**Addendum No. 1**

**Subject: J. Hampton Moore School  
Major Renovation Phase 2B – Interior Renovations  
SDP Contracts No. B-083C and B-084C of 2016/17**

**Location: J. Hampton Moore School  
1100 Tyson Avenue  
Philadelphia, PA 19111**

**This Addendum, dated 7th of November, 2017, shall modify and become part of the Contract Documents for the work of this project. Any items not mentioned herein, or affected by, shall be performed strictly in accordance with the original documents.**

3 SUSPENDED LUMINAIRE MOUNTING DETAIL

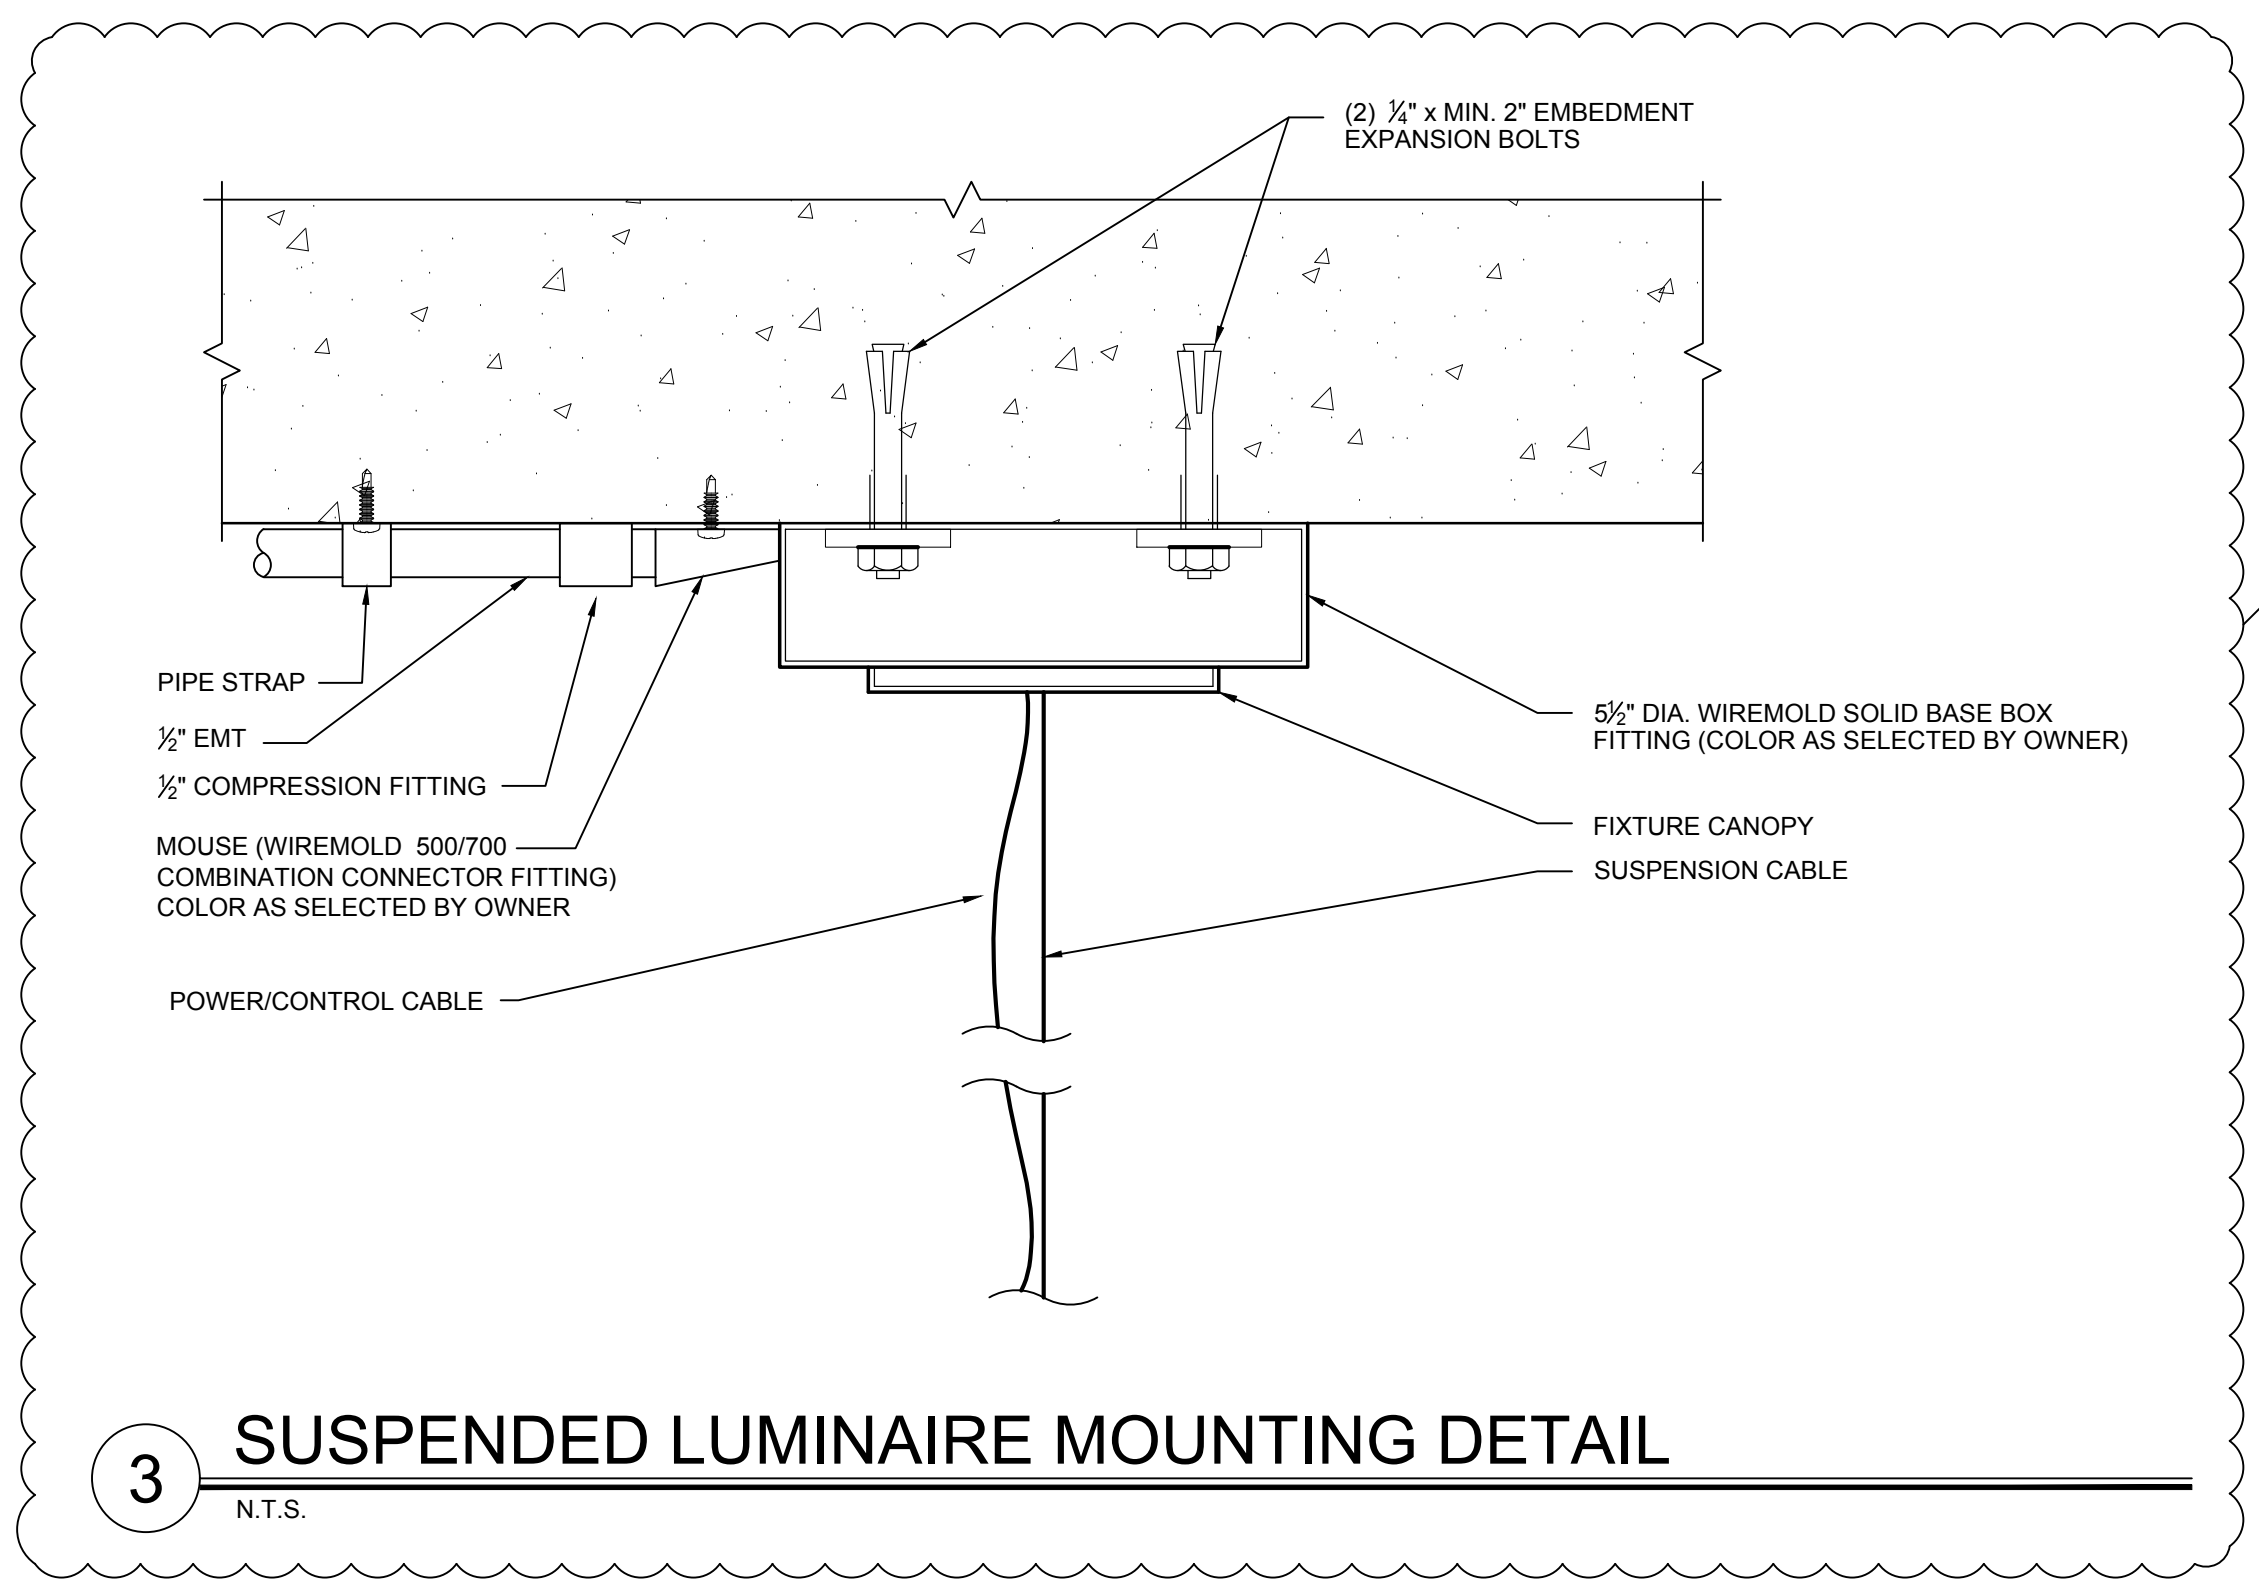
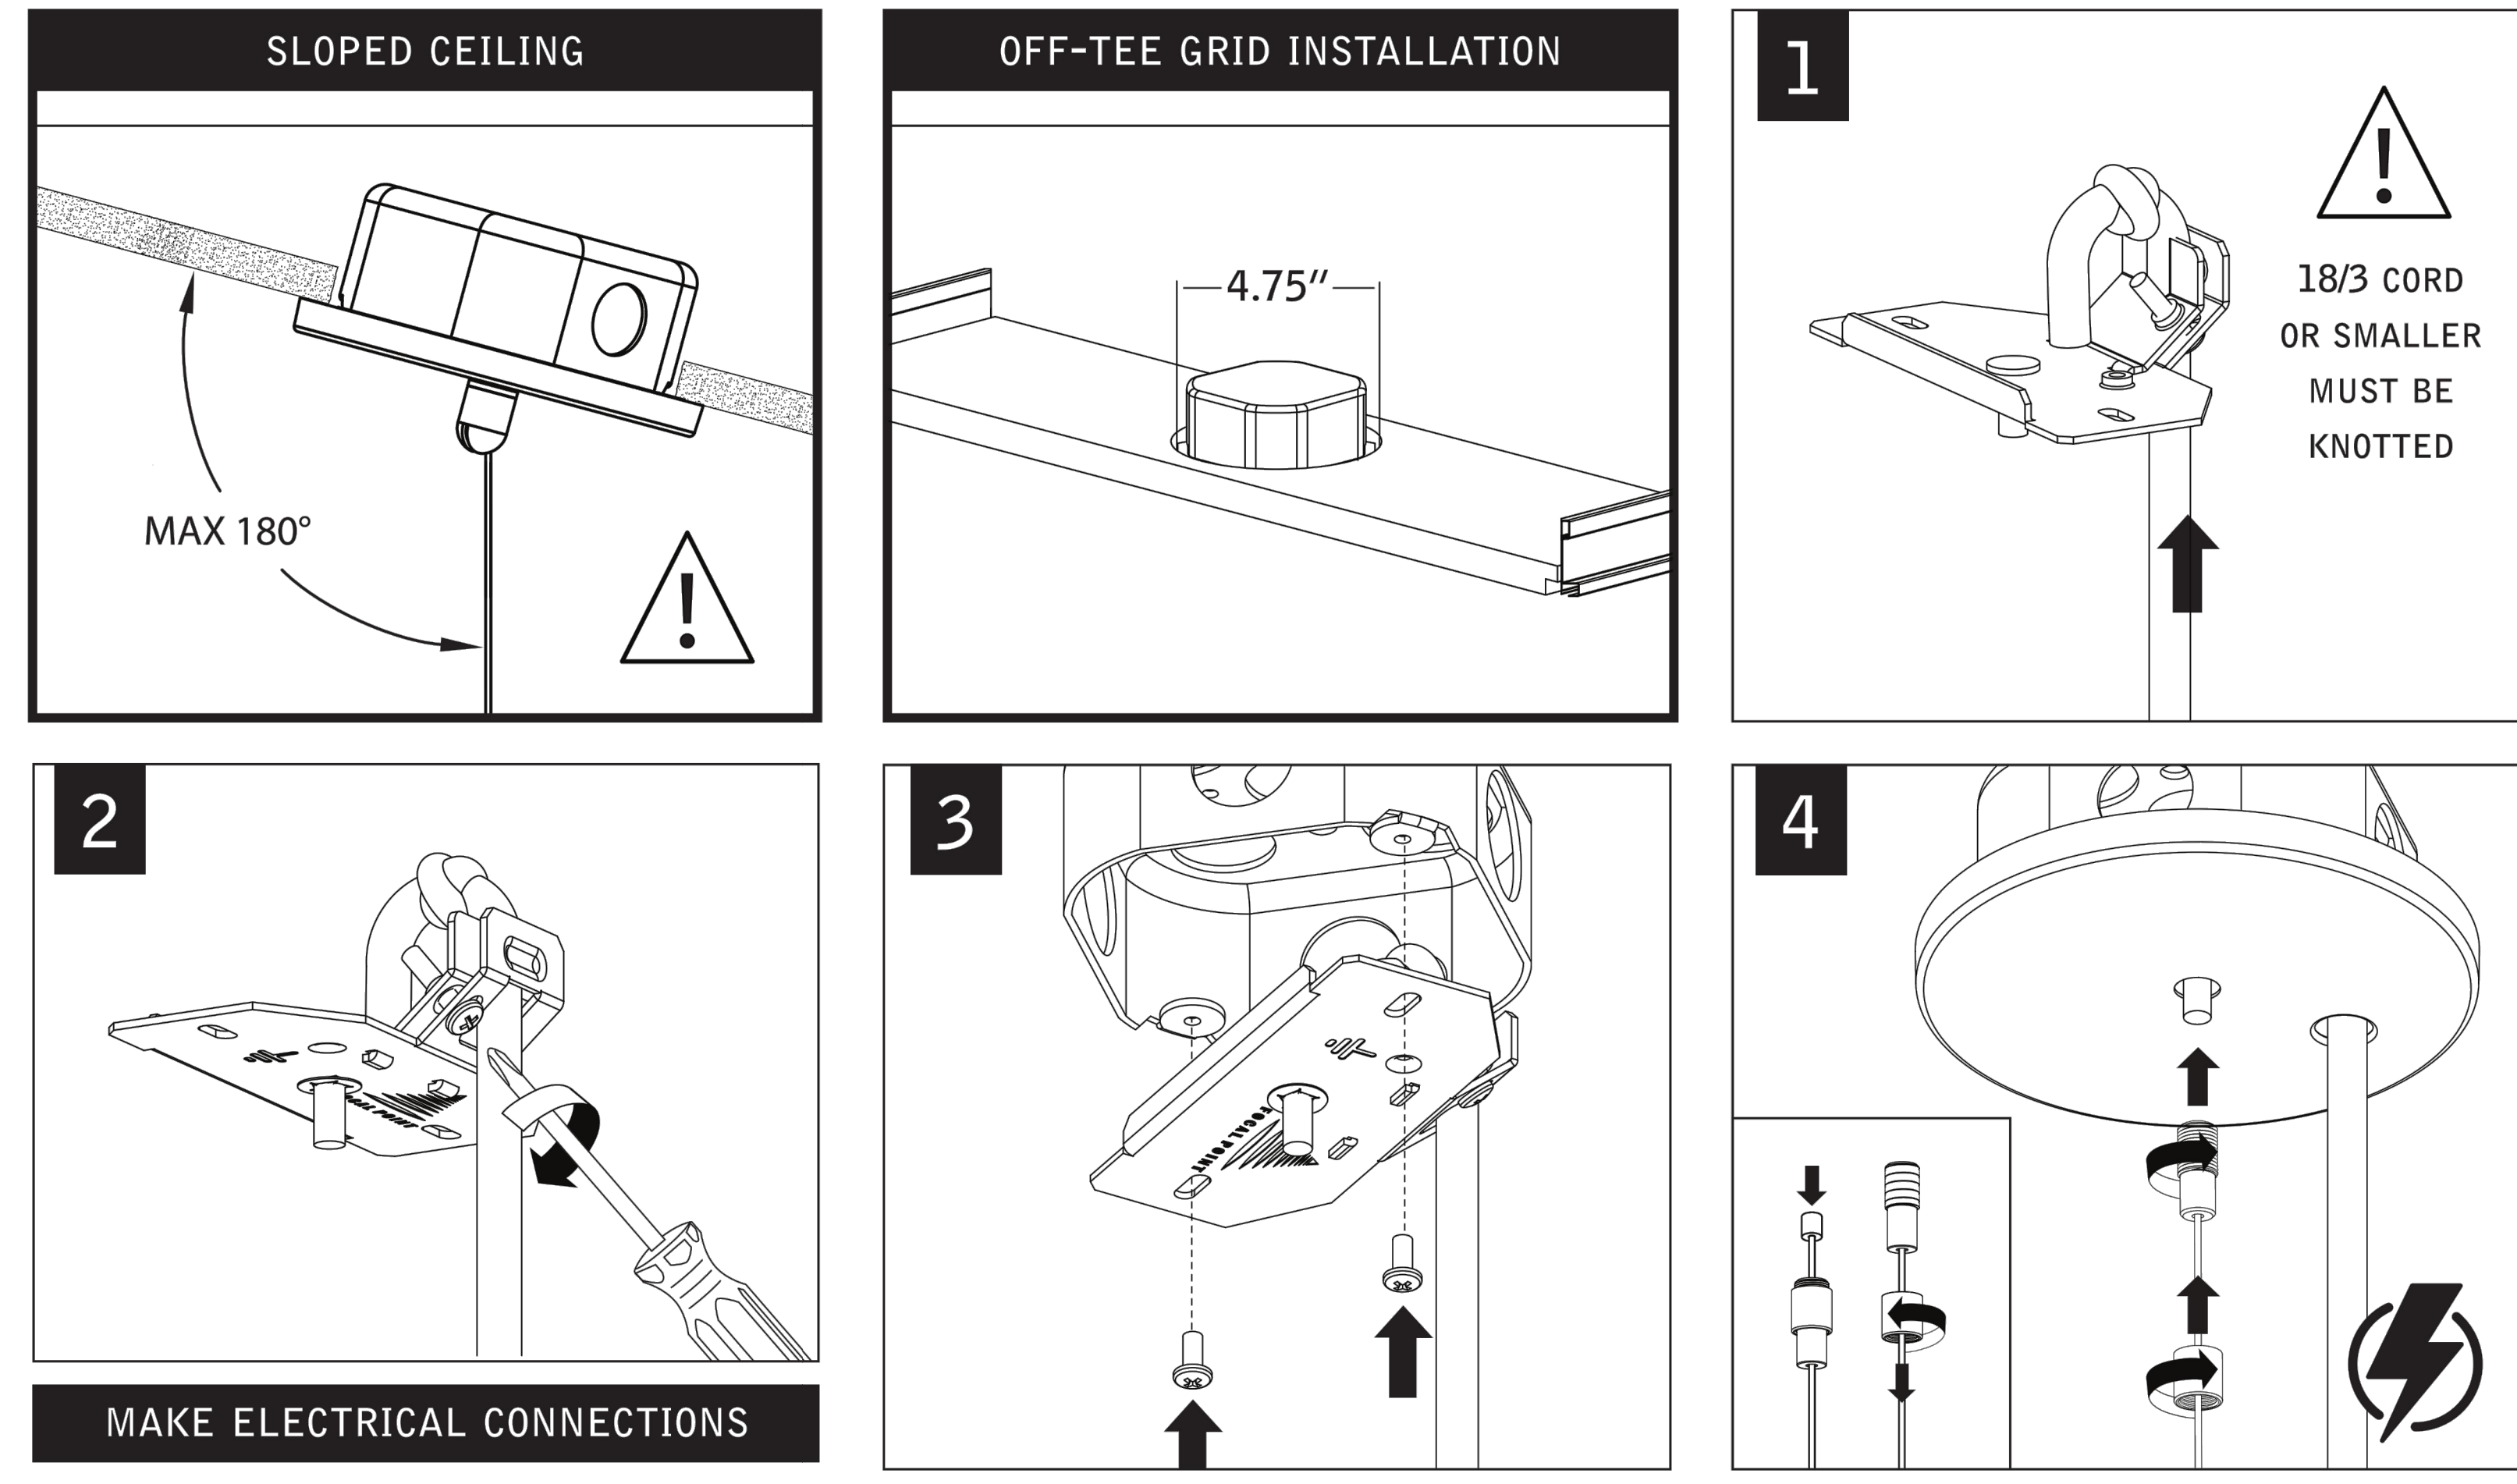
- 1. Drawing E2.02 is revised to include PA speakers and wireless clocks in the new modular building. The modular building is provided by others and is not part of this project.**
- 2. Drawing E5.04 – Detail 3 mounting detail is modified to include power/control cable.**
- 3. Drawing E6.01 – PNL L main rating changed to 225A; PNL L breaker at MDP2 changed to 175A; feeders from MDP2 to PNL L changed to 4 #2/0 & 1-#6 Gnd.**
- 4. Drawings FA.01 thru FA.04 – Notification circuit power booster (NAC) added to symbol legend; Location of NAC have been indicated on plans; Note 4 and 6 have been modified.**

- SUSPENDED LIGHTING MOUNTING DETAIL NOTES:**
1. STOP SLEEVE ON AIRCRAFT CABLE MUST ALWAYS BE IN A FREE STATE. LOCKING OR CLAMPING OF THE STOP-SLEEVE WILL VOID FOCAL POINT WARRANTY CLAIMS.
  2. CANOPY ASSEMBLY DESIGNED FOR UP TO 18/3 CABLE. 18/3 CABLE OR SMALLER MUST BE TIED IN KNOT, WHERE NOTED IN THE FOLLOWING INSTRUCTIONS, FOR STRAIN RELIEF.
  3. DETAILS ARE TAKEN FROM THE SPECIFIED MANUFACTURER'S. SUBSTITUTE MANUFACTURER MAY VARY. CONTRACTOR SHALL USE INSTALLATION SPECIFICATIONS FROM THE LUMINARIES MANUFACTURER THAT IS PURCHASED.
  4. ALL EXPOSED CONTROL WIRE SHALL BE SAME COLOR AS EXPOSED FEED WIRE.
